RE: ADDENDUM #3
RFP #B131027, Elevators for Record Storage Facility
RFP #B131028, Painting for Record Storage Facility
RFP #B131029, Mechanical for Record Storage Facility
RFP #B131030, Electrical for Record Storage Facility
RFP #B131031, Plumbing for Record Storage Facility
RFP #B131032, Fire Suppression for Record Storage Facility

ADDENDUM NO. 3

Record Storage Facility ..... Old North Jail
Second Floor Renovations ..... Annex
Hurricane Ike Repairs:
PW 14465 ..... Elevator at Old North Jail
PW 14498 ..... Elevator at Old Courthouse Annex
PW 14499 ..... Elevators at South Jail Parking Garage
PW 15601 ..... Old North Jail - A
PW 15601 ..... Old Courthouse Annex - B
PW15079 ..... N Jail/Annex Asbestos Abatement

Prepared by: Galveston County Architect
Project No.: 09-009

ADDING FIRE ALARM DEVICES
GALVESTON COUNTY
HURRICANE IKE REPAIRS – FIRST FLOOR
ELECTRICAL E2.01

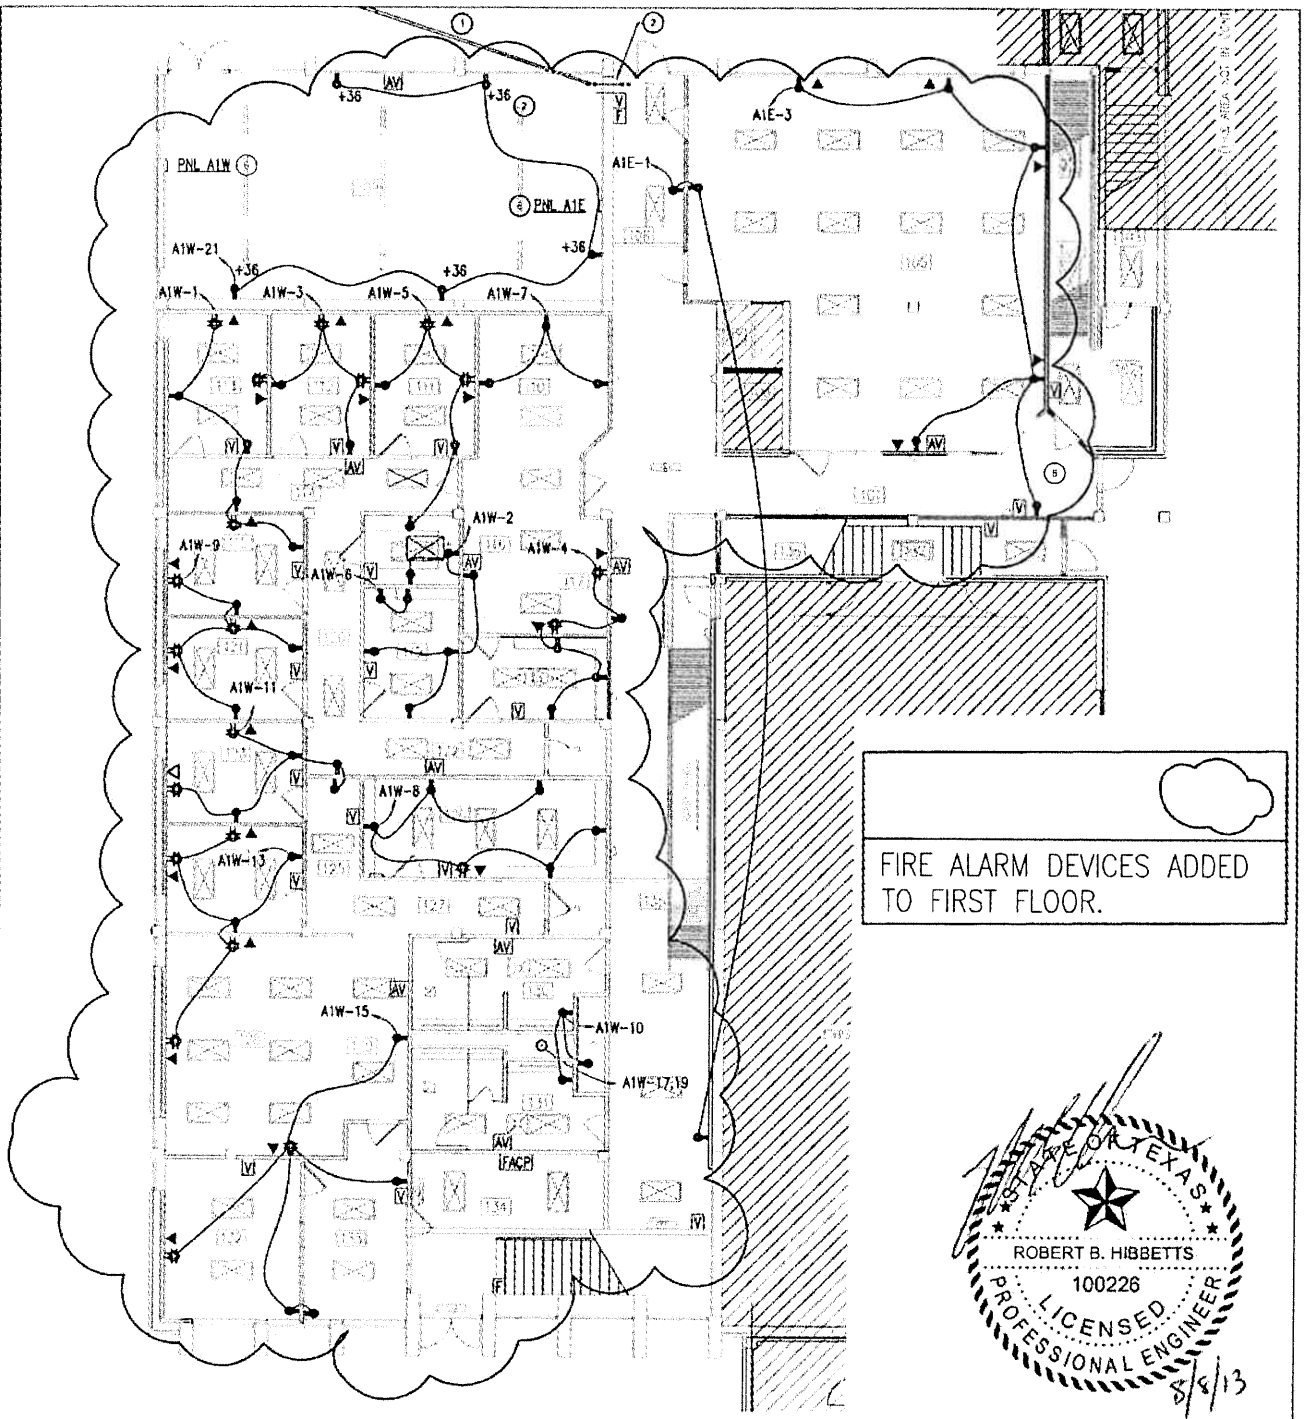
FIRE ALARM DEVICES ADDED TO FIRST FLOOR.

THIS DRAWING SUPERCEDES SHEET E2.01 ONLY AS SHOWN

ADDING FIRE ALARM DEVICES
GALVESTON COUNTY
HURRICANE IKE REPAIRS – FIRST FLOOR
ELECTRICAL E2.01

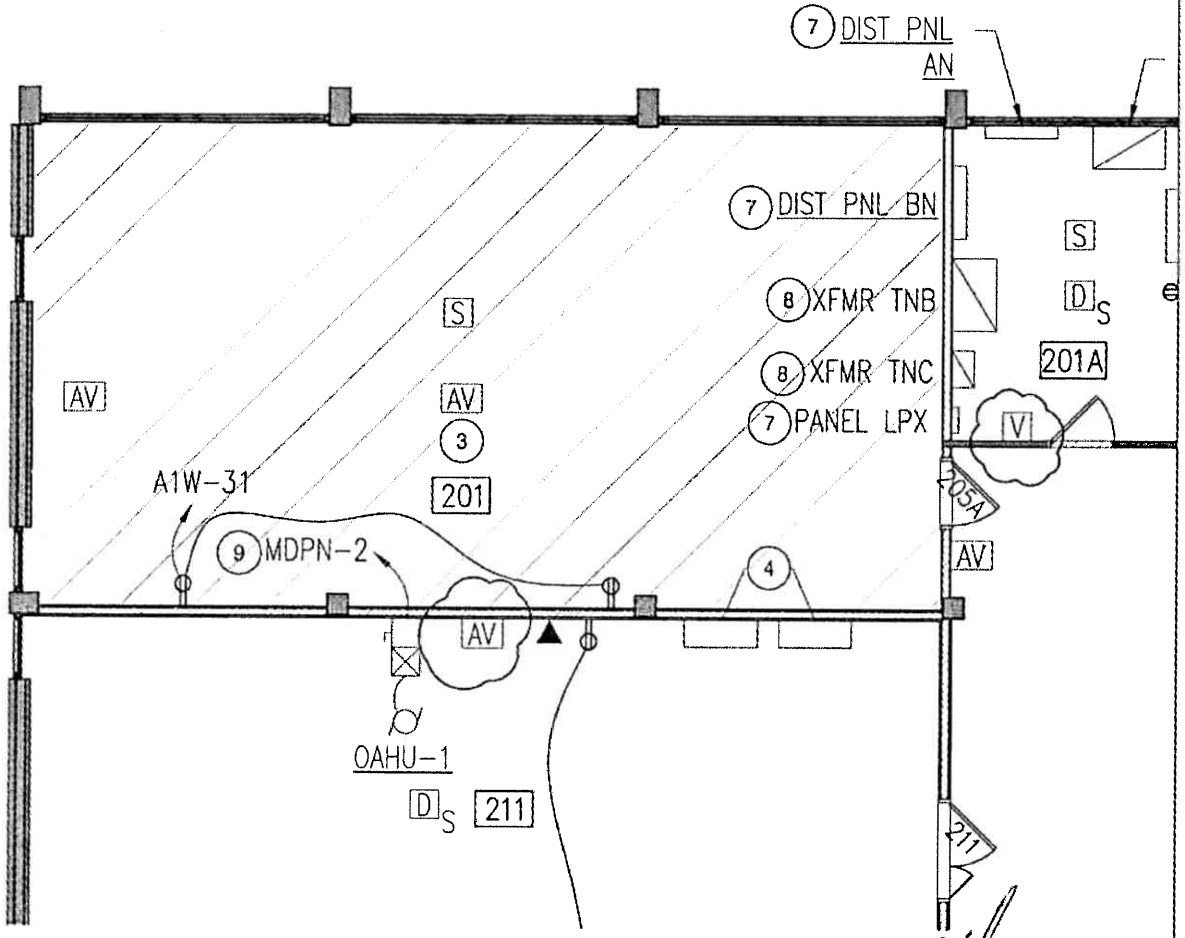
FIRE ALARM DEVICES ADDED TO 2ND FLOOR.

THIS DRAWING SUPERCEDES SHEET E2.01 ONLY AS SHOWN

ADDING FIRE ALARM DEVICES
GALVESTON COUNTY
SECOND FLOOR–OLD COUNTY COURTHOUSE ANNEX
ELECTRICAL E2.01

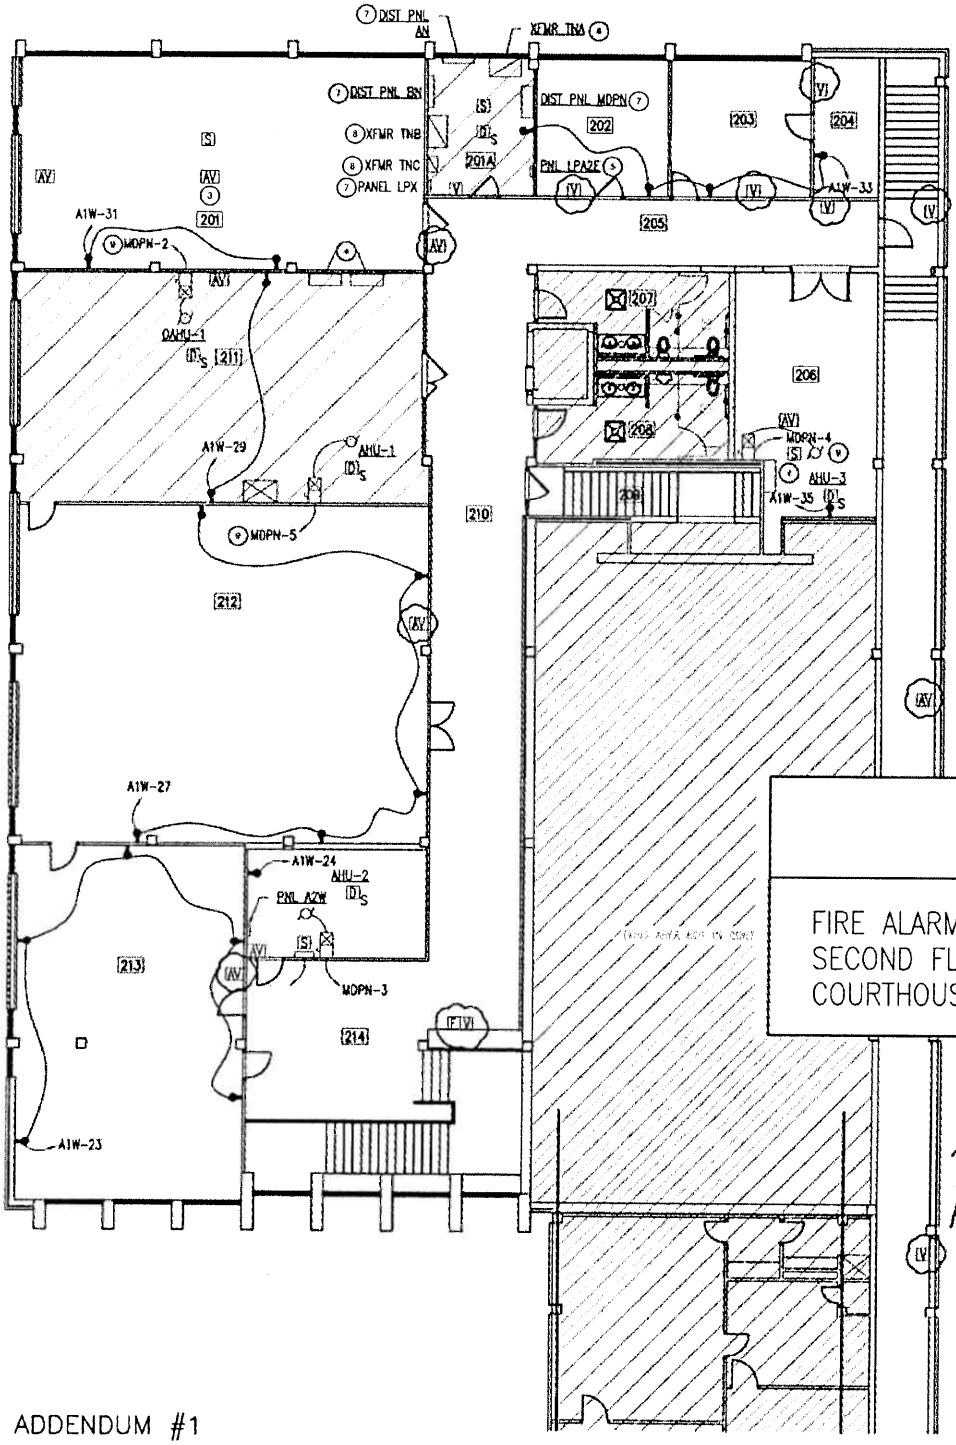
FIRE ALARM DEVICES ADDED TO SECOND FLOOR – OLD COURTHOUSE ANNEX.

THIS DRAWING SUPERCEDES SHEET E2.01 ONLY AS SHOWN
